From: Christie Kearney
To: Johnson, Bill H (DNR)
Cc: Oswald, Caroline (She/Her/Hers) (DNR); Ciardelli, Mark C; Kramka, Larry; Colin Marsh; Lucas Miller
Subject: RE: Query 12 - Mine Site Equalization Basin
Date: Tuesday, August 11, 2026 7:00:52 AM
Attachments: image001.png
image002.png
image003.png
image004.png
image005.png
image006.png

Hello Christie. This is Query 12 to support DNR's consideration of NewRange's request and material evidence for the NewRange NorthMet Mining Project.

This query has three parts to better understand contact water management at the Mine Site without a WWTF in the revised project:

Below is a cutout from Figure 2 at the Mine Site. According to the legend, the 9 locations that are numbered below should each represent an equalization basin.

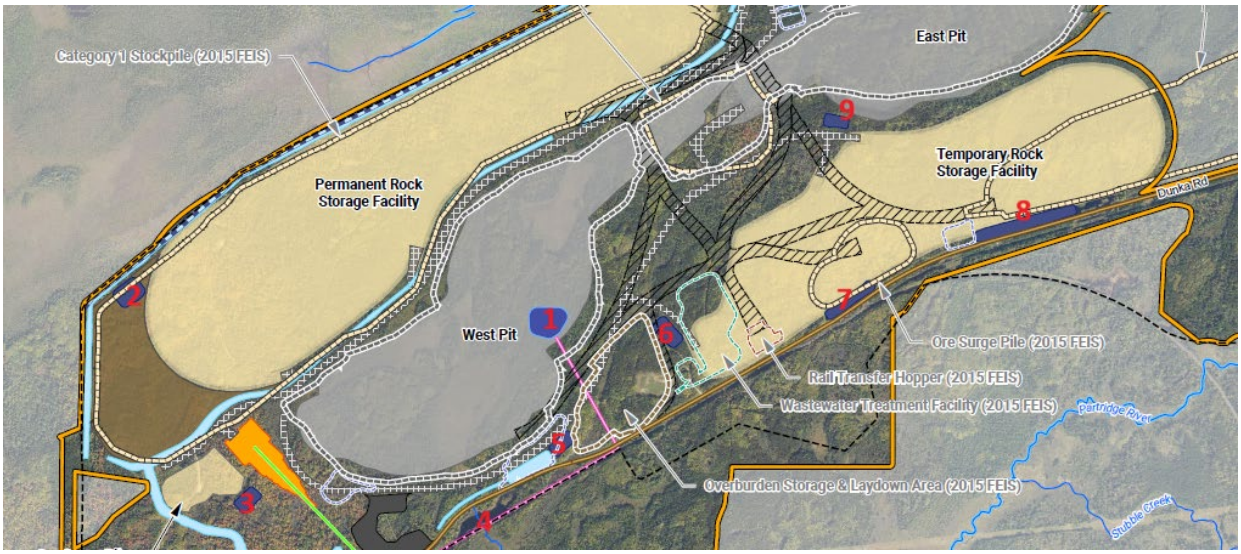
Question: Is it correct that there are 9 equalization basins proposed for the Mine Site? Will these be lined or not?

Part 3 focuses on the equalization basin listed at No. 1 in the red numbering in the cutout. No. 1 is also the basin being referenced in Part 1 above).

Question: Is No. 1 the basin that is to receive “water collected from the mine pits, rock storage facilities, OSP, and ancillary mine features…[where] water within the equalization basin is pumped via a pit-to-plant pipeline…to the Plant Site for re-use” as stated in Table 1? It seems like this collection contact water is more dispersed across the site but maybe not.

NewRange Response: There are two different blue polygons in the legend, one is the equalization basin with a light blue outline (there is one, located within the West Pit) and the other are the contact water ponds with a dark blue outline (there are 7). What you have labeled as #4 is an existing pond shown on the aerial photo, which just happens to be close to the same color as our contact water ponds.

NewRange Response: Yes, the basin you show as #1 above is the equalization basin that “will store contact

water collected at the Mine Site before it is pumped via a pit-to-plant pipeline to the Plant Site for reuse." Mine Site contact water is collected from the mine pits, RSF, OSP, and ancillary facilities in the Mine Site contact water ponds and sumps and pumped to the equalization basin. This is the same way Mine Site contact water was managed in the 2015 FEIS and 2018 permitting – collected at ponds and sumps at the source and then pumped to the equalization basins before being routed to its destination (WWTF or Plant Site, respectively).
